In Reply Refer To:
HSST-1/B-265 REVISED

- Modified Three-Tube Bridge Rail (BR208)

Request for Federal Aid Reimbursement Eligibility of Highway Safety Hardware using Finite Element Analysis (FEA)

TITLE OF PROJECT BARRIER CRASH TEST SIMULATION	CONTRACT NUMBER:
LOCATION OF PROJECT	DATE: 04/19/2016
TITLE OF DRAWING UNIT 11 - SUPERSTRUCTURE BRIDGE BARRIERS OUTLINE & REINFORCEMENT 2	DRAWING NUMBER:

STEEL BRIDGE RAILING FOR MAIN SPANS - ELEVATION
SCALE: 1/2" = 1'-0"

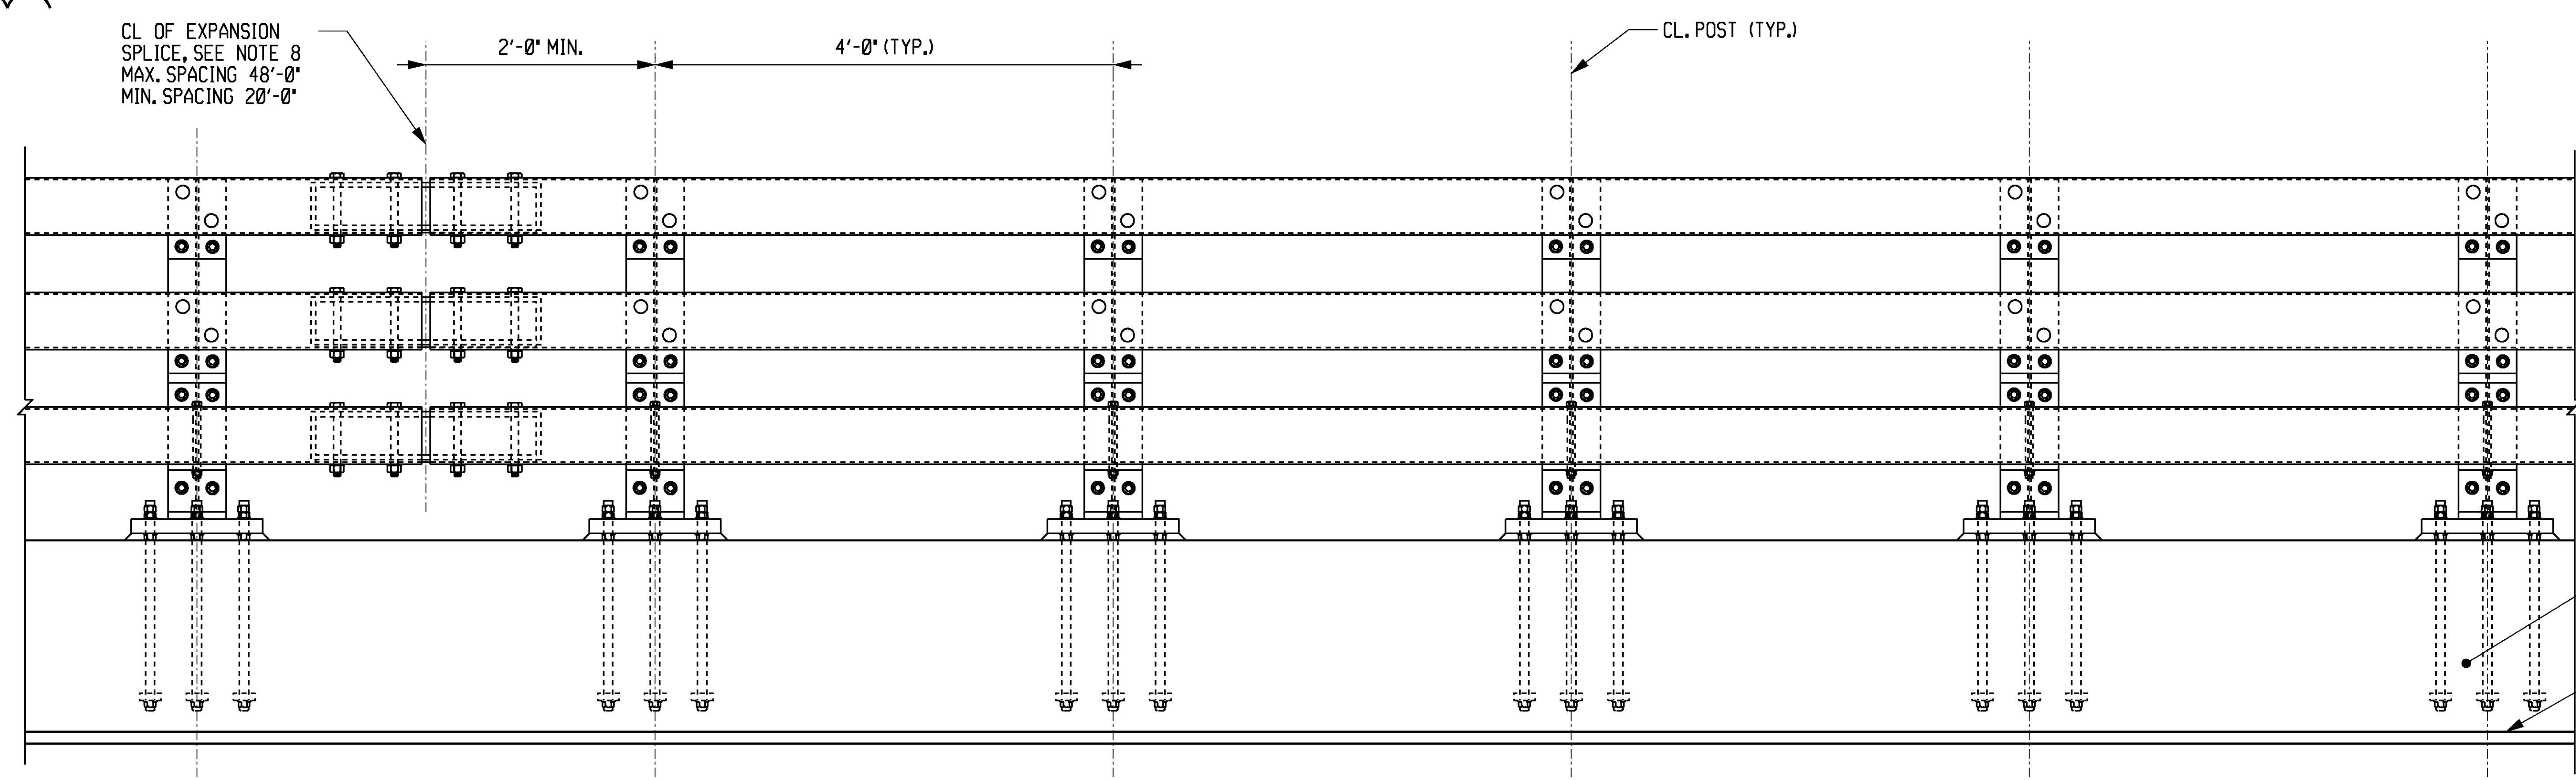
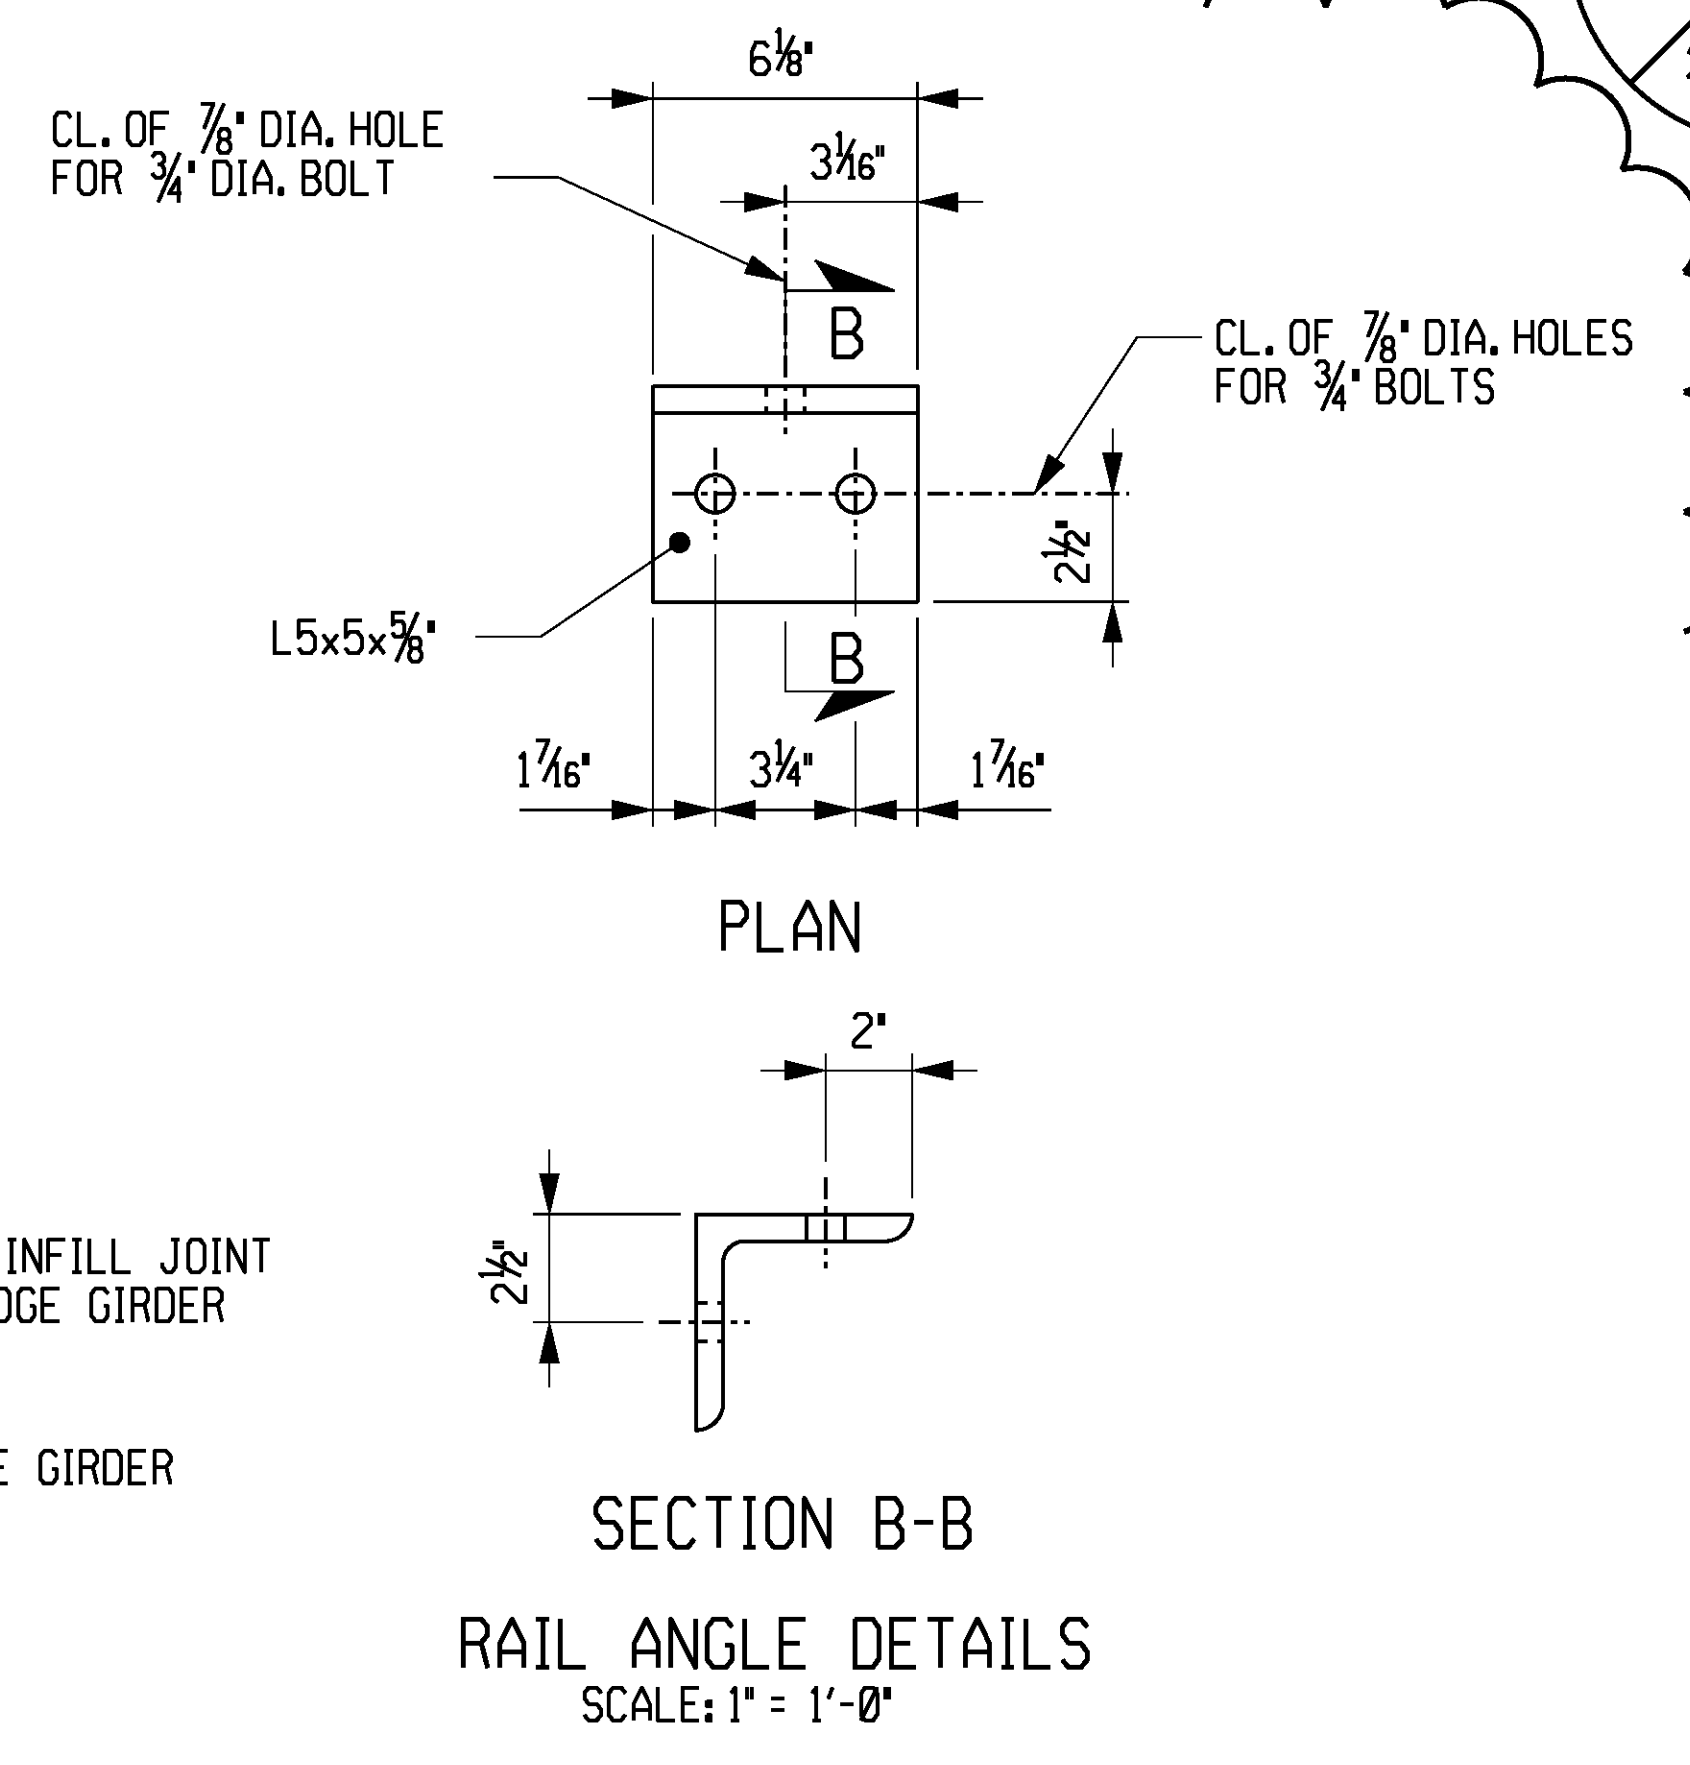
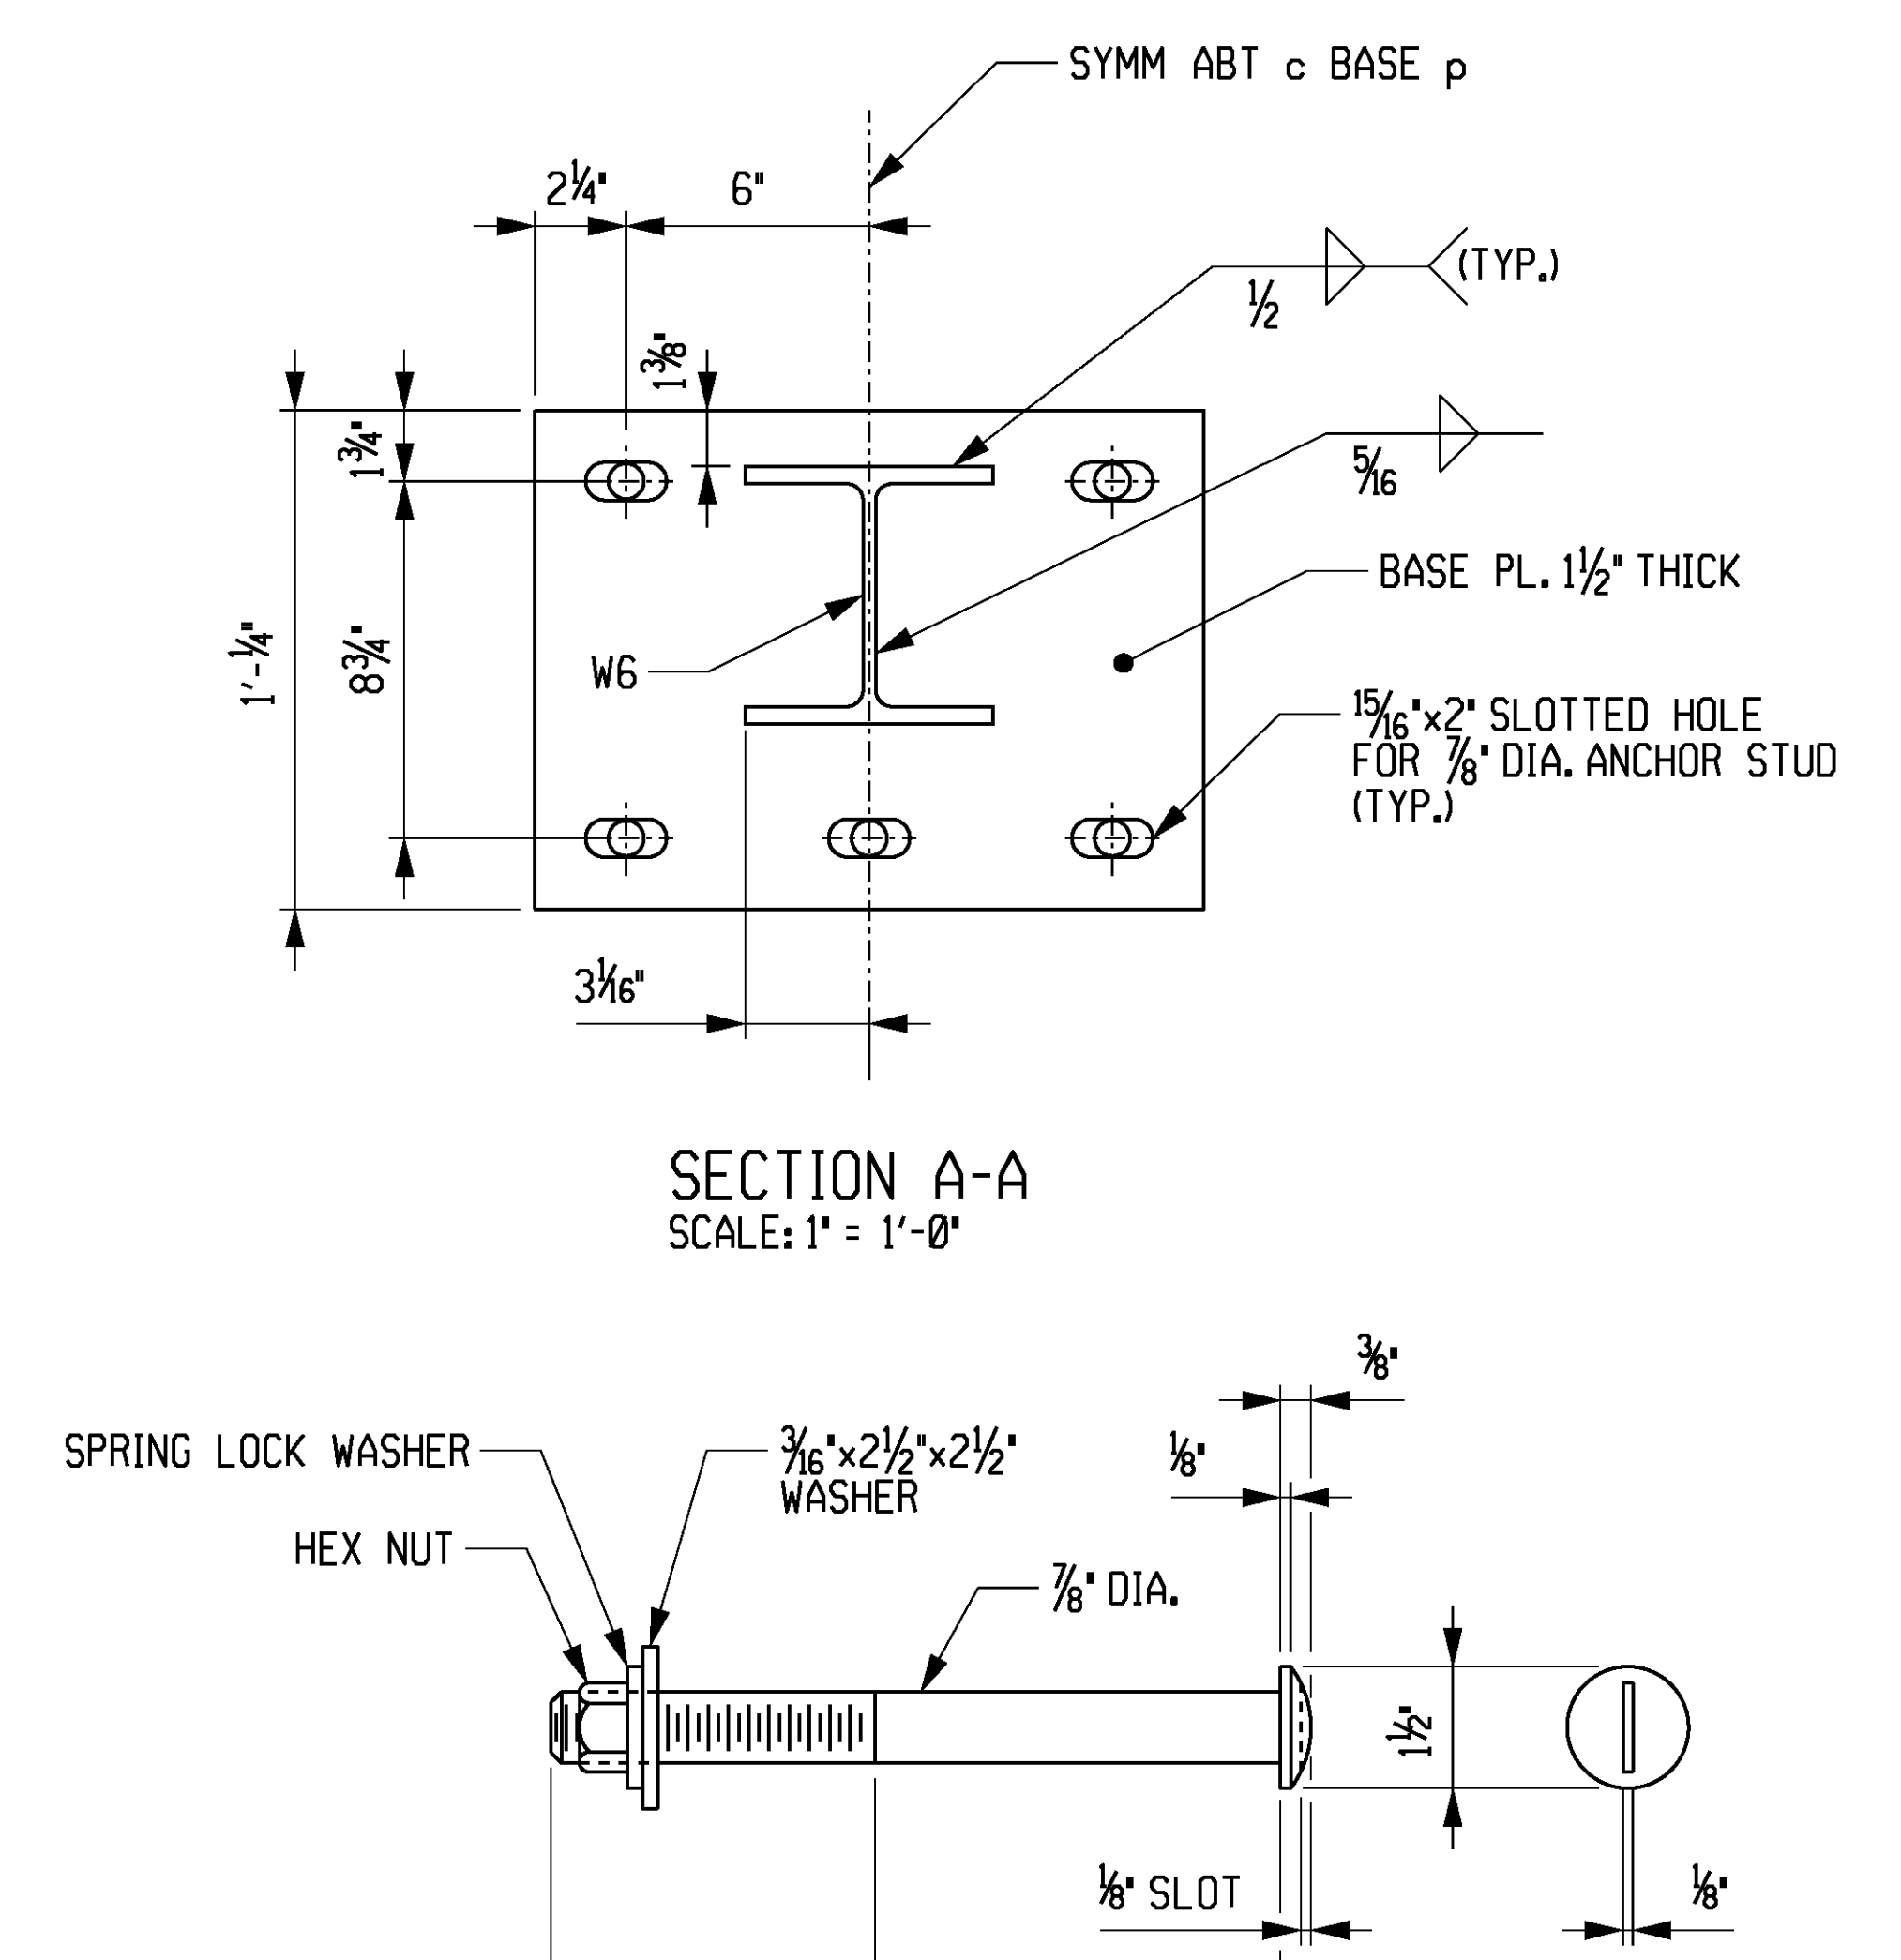
1. Changing the post type from a W8x24 to W6x25.
2. Decreasing the post spacing from 9.84 feet on center to 4 feet on center.
3. Increasing the overall top-of-rail height from 42 inches to 45 inches.

4. Eliminating the block out sections for lower rails and changing the rail sections to TS 6 x 6 x 3/16 inch for all three rails. The design also includes a 1/2-inch thick shim plate between the post and rails, which was not included in the model. With the shim plate the resulting distance from the traffic face of the rails to the front flange of the posts is 6.5 inches, which is 1/2 inch less than the BR208.

5. Replacing the 3/4-inch diameter stud bolts that fasten the rails to the posts in the original system with 3/4-inch diameter round-head bolts for the top and middle rails. The lower rail in the modified design is supported on an L5 x 5 x 5/8 inch angle section with a single 3/4-inch diameter bolt passing vertically through the tube and angle support bracket. The support is fastened to the post using two 3/4-inch bolts with nuts and washers.

6. Increasing the number of mounting bolts used to fasten the bridge rail to the top of the curb from 4 bolts to 5 bolts. The additional bolt is placed on the traffic side of the mount-plate (tensile side) in-line and at the midpoint of the other two mounting bolts.

7. Increasing the embedment depth for the anchor bolts from 14 inches to 16.75 inches.
8. Increasing the curb width by 3/4-inch (i.e., increasing from 19.5 inches to 20.25 inches).

FHWA concurs with the recommendation of the accredited crash testing laboratory as stated within the attached form.
